South Texas Project
Units 3 and 4
Docket Nos. 52-012 and 52-013
Supplemental Response to Request for Additional Information

RAI 03.07.01-27, Supplement 3**QUESTION:****Follow-up Question to RAI 03.07.01-19 (STP-NRC-100093)**

RAI 03.08.04-30 Supplement 2**QUESTION:****Follow-up to Question 03.08.04-23**

Figure 3H.7-30a: Amplified N-S Site-Specific Response Spectra
Diesel Generator Fuel Oil Tunnel (DGFOT)

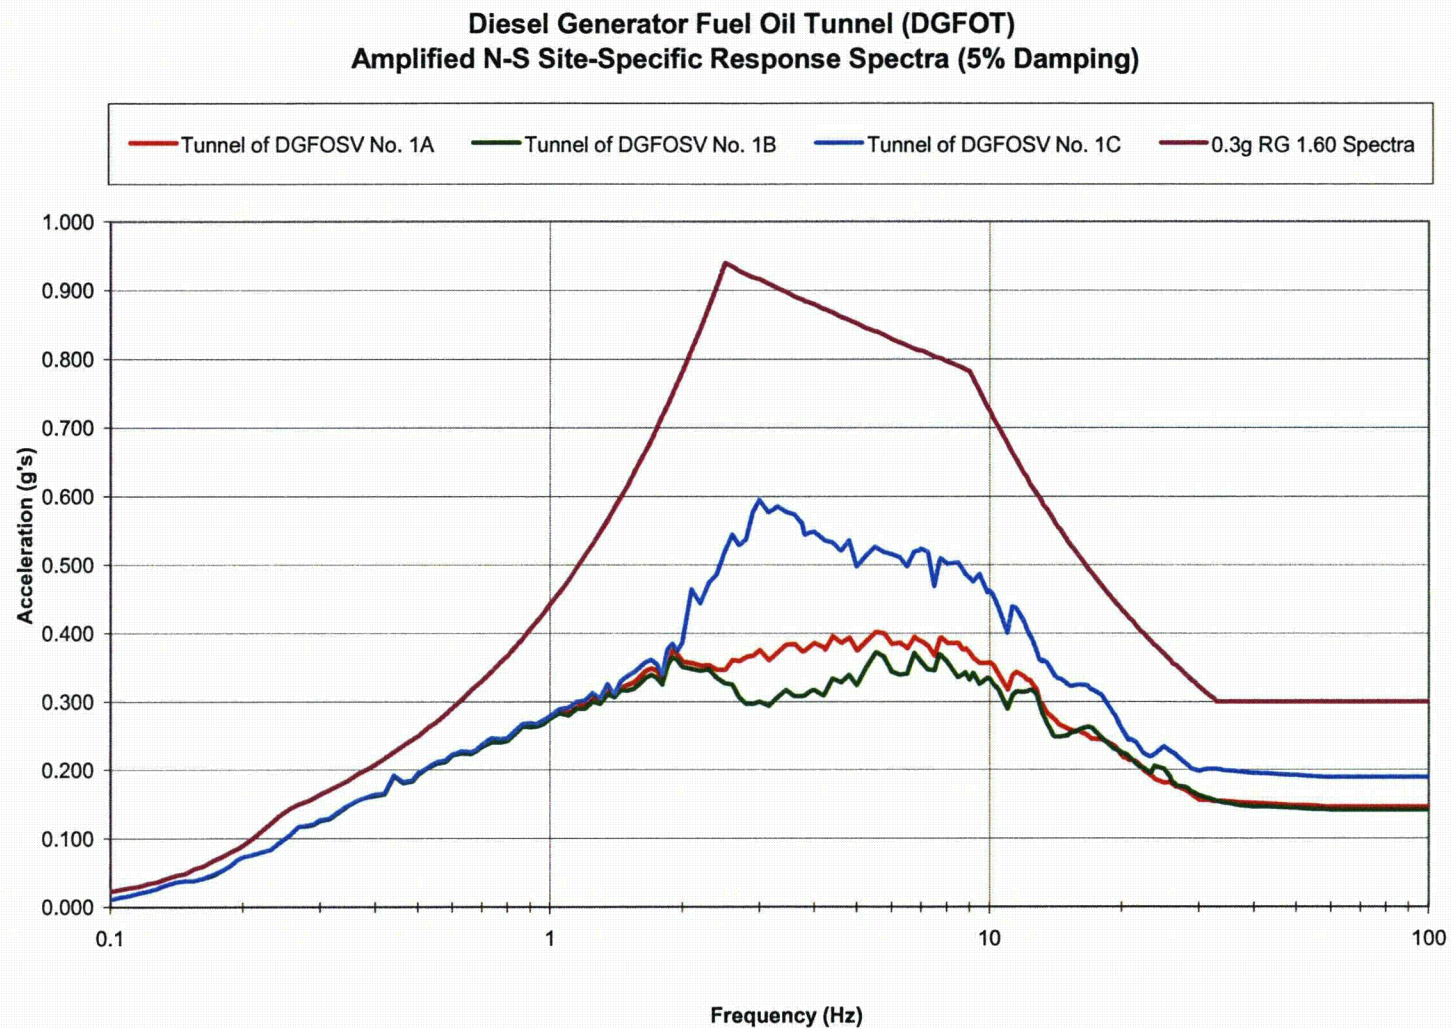
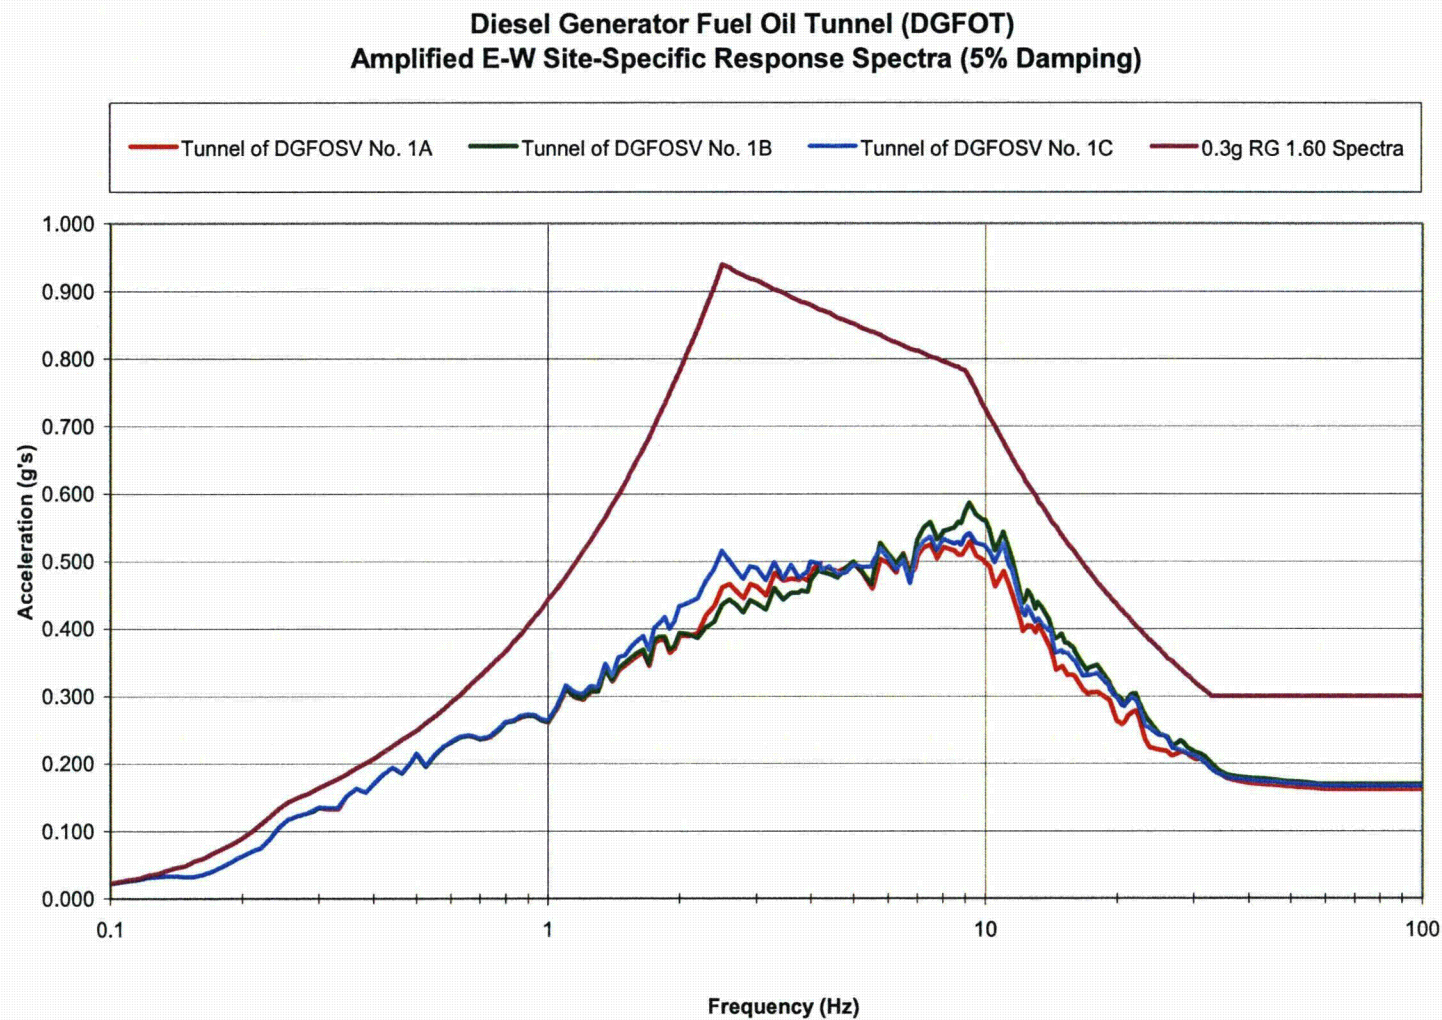
NINA was requested to include in COLA the amplified site-specific response spectra for RSW Piping Tunnel, DGFOVS, and DGFOT (Audit Action Item 3.7-22). See the discussion provided in the following paragraphs.

Guide 1.60 response spectra were used for SSI analysis of the DGFOT. As shown in new COLA Figures 3H.7-30a through 3H.7-30c, the 0.3g Regulatory Guide 1.60 response spectra were found to be the bounding spectra.

Amplified site-specific response spectra of DGFOT for 5% damping are provided in new COLA Figures 3H.7-30a, 3H.7-30b, and 3H.7-30c. As shown in these figures, the 0.3g Regulatory Guide 1.60 spectra, which were used for the SSI analysis, envelop the amplified site-specific response spectra.
